**RE: GONZALES WELL NO. 3 - WELL EQUIPMENT AND COLLECTOR LINE
FINAL SITE GRADING AND DRAINAGE PLAN FOR BUILDING PERMIT
APPROVAL - PWD NO. 4291.92**

RE: Grading and Drainage Plan for Gonzales Well No. 3 (G11/D43A) Submitted for Building Permit Approval, Engineer's Stamp Dated 2/4/98.

**RE: GRADING AND DRAINAGE PLAN FOR GONZALES WELL NO. 3 (G11/D43A)
SUBMITTED FOR SITE DEVELOPMENT PLAN FOR BUILDING PERMIT APPROVAL,
ENGINEER'S STAMP DATED 11/29/95.**

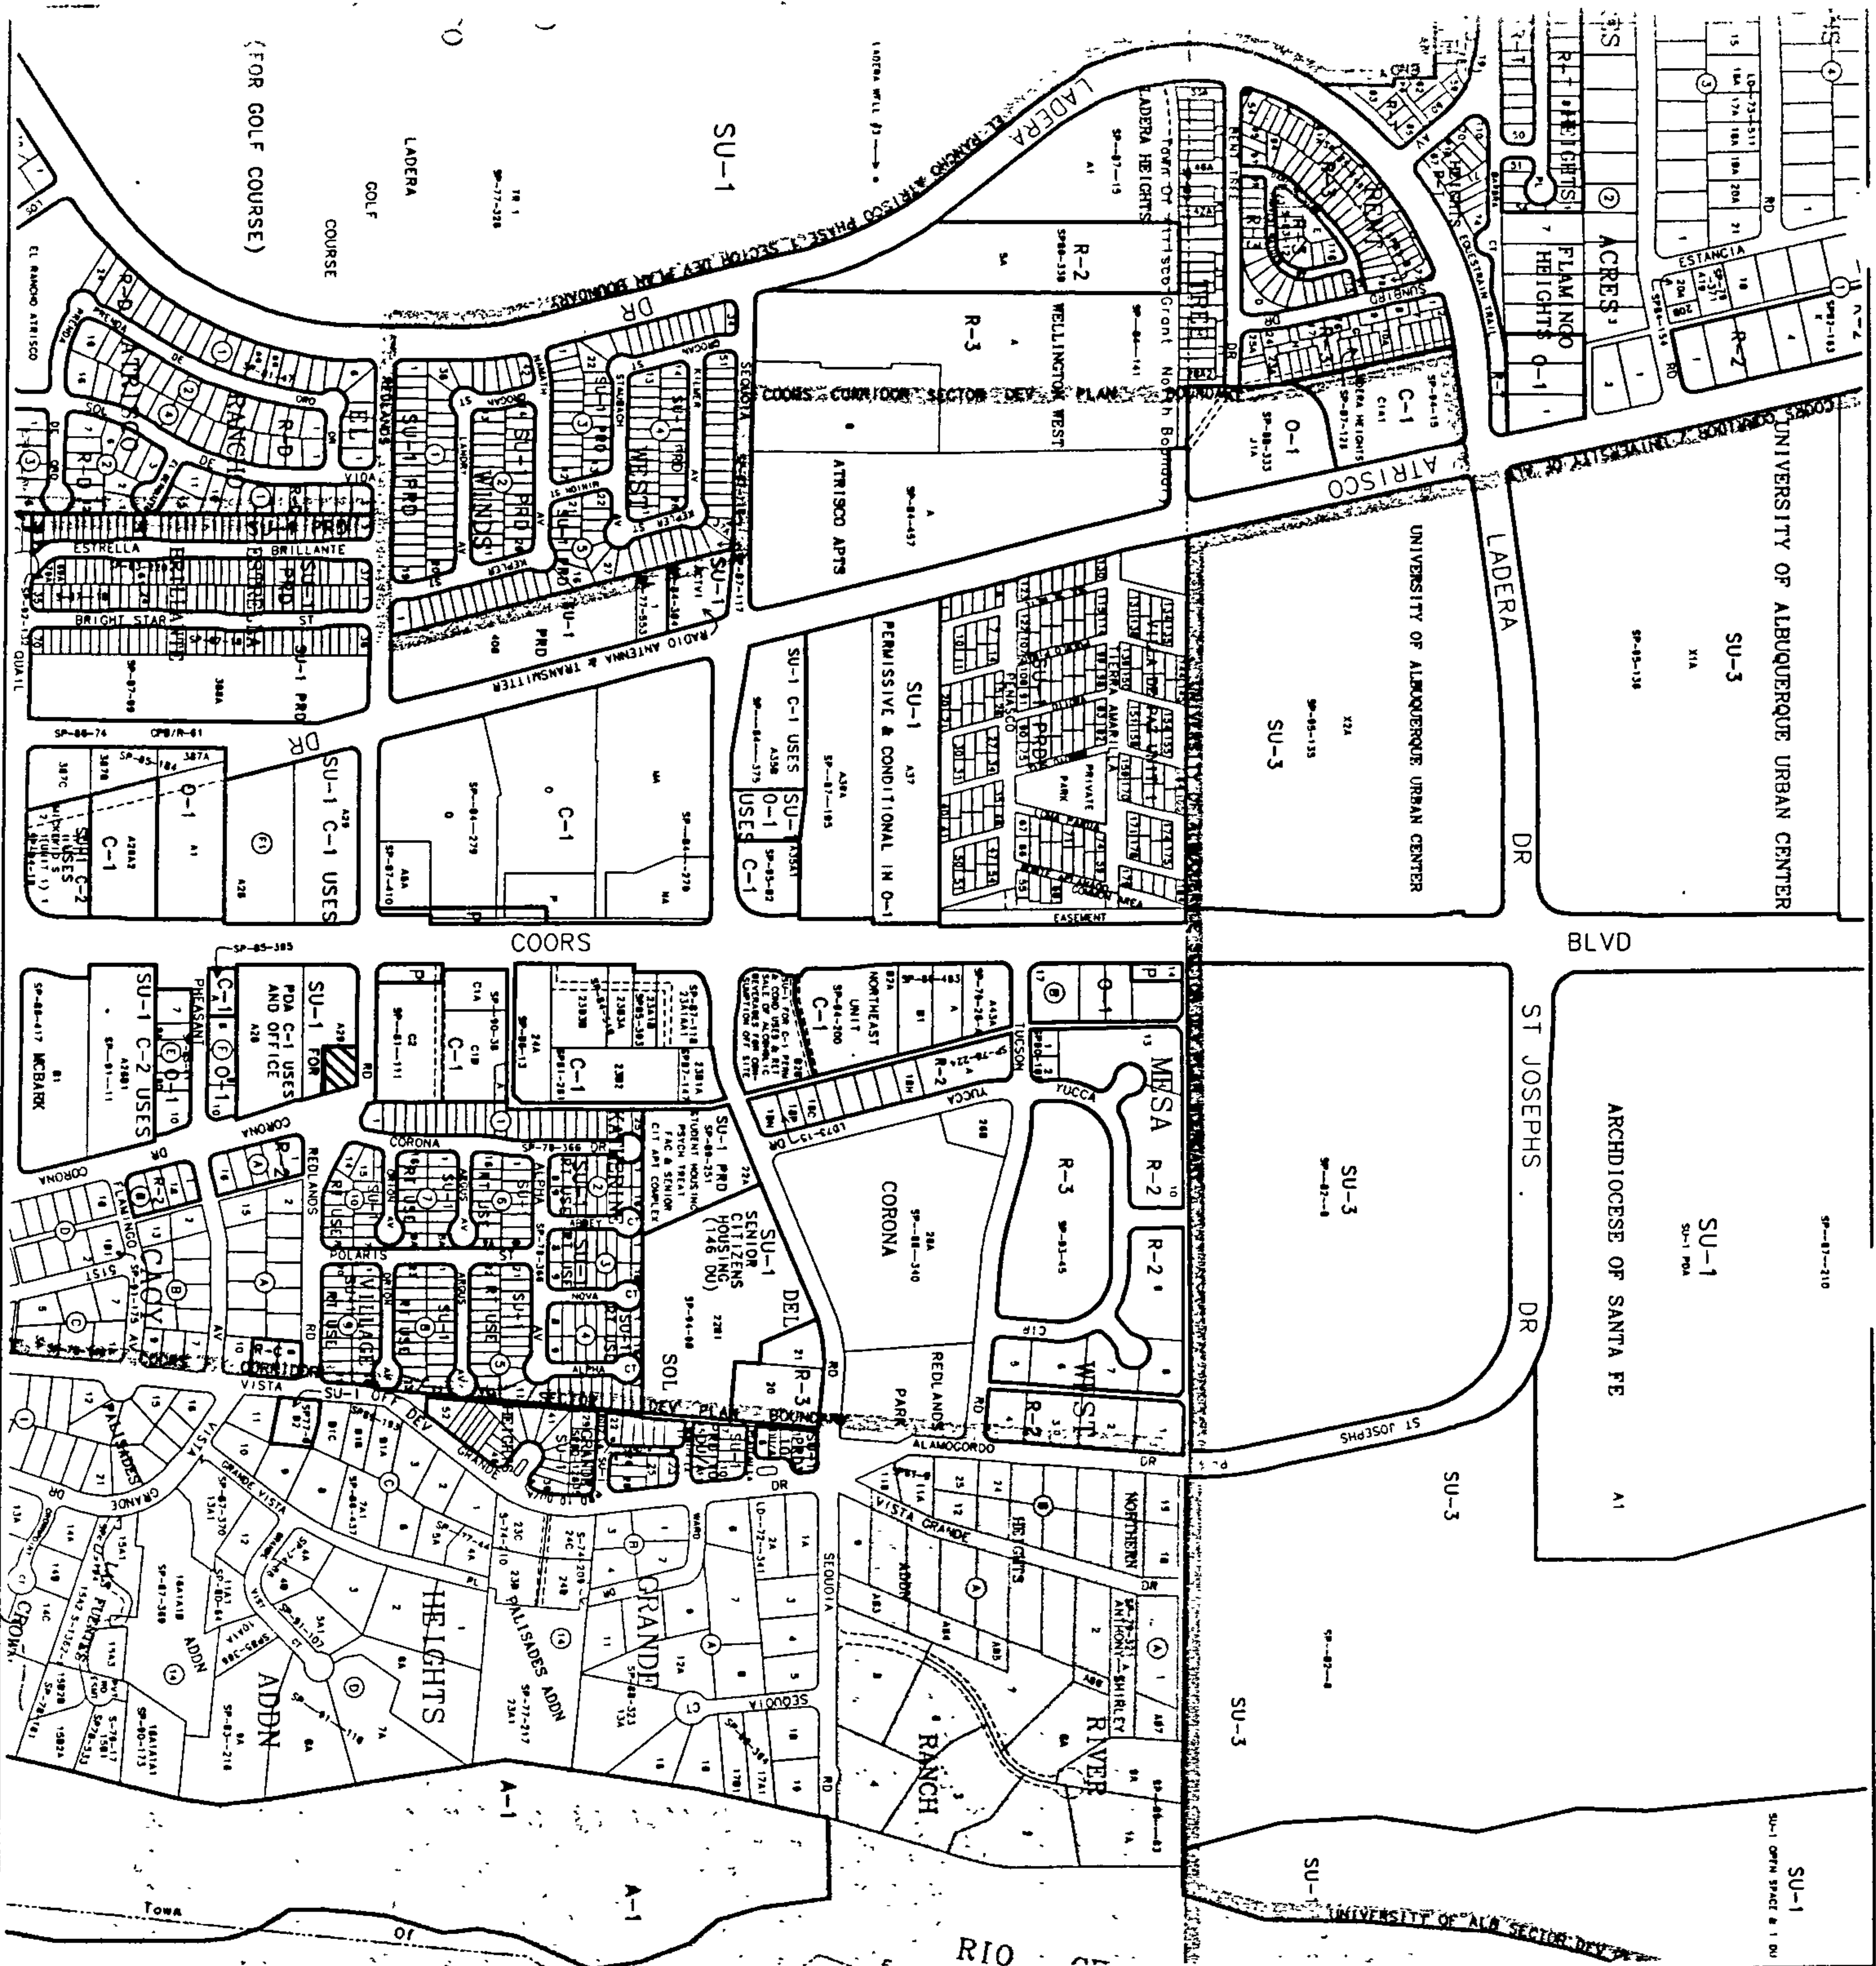
1. On the plan, provide a copy of the portion of the FEMA Flood Insurance Rate Map (FIRM) showing the site delineated on it. Please use and reference the current FIRM panel, dated September 20, 1996. Is the entire site, or only a portion, located within the published FEMA floodplain? If possible, show the limits of the floodplain on the plan.
2. Plot the hydraulic grade line (HGL) on the profile of the storm drain to show that it won't back up onto the parking lot during the 100-year event.

1. On the plan, provide a copy of the portion of the FEMA Flood Insurance Rate Map (FIRM) showing the site delineated on it. Please use and reference the current FIRM panel, dated September 20, 1996. Is the entire site, or only a portion, located within the published FEMA floodplain? If possible, show the limits of the floodplain on the plan.
2. Plot the hydraulic grade line (HGL) on the profile of the storm drain to show that it won't back up onto the parking lot during the 100-year event.

Please find enclosed the revised final Site Grading and Drainage Plan (Plan) which includes the two additional items that were identified in your letter of March 3, 1998 (copy enclosed) and the drainage information sheet for the project (enclosed). These two items, identified in your letter, are: 1) a portion of the FEMA Flood Insurance Rate Map showing the location of the site with respect to the 100-year floodplain, and 2) the hydraulic grade line (HGL) for the 24-inch and 18-inch storm drains on the well site.

The HGL is based on peak flows in the main storm drain (48-inch RCP in Redlands Road) and the on-site drainage system during the 100-year storm event. Record drawings obtained from the City show that during this event, the HGL for the main storm drain will be approximately 5.4 feet above the top of pipe (Elevation 5096.5) at the 24-inch connection. Our analysis indicates that the impact of on-site drainage on the HGL will be imperceptible. The HGL in the main storm drain will be the prevailing condition. However, as shown on the Plan, there will be adequate freeboard (2.7 - 3.2 feet) in the storm inlets and washline manhole to preclude flooding of the grounds during this event.
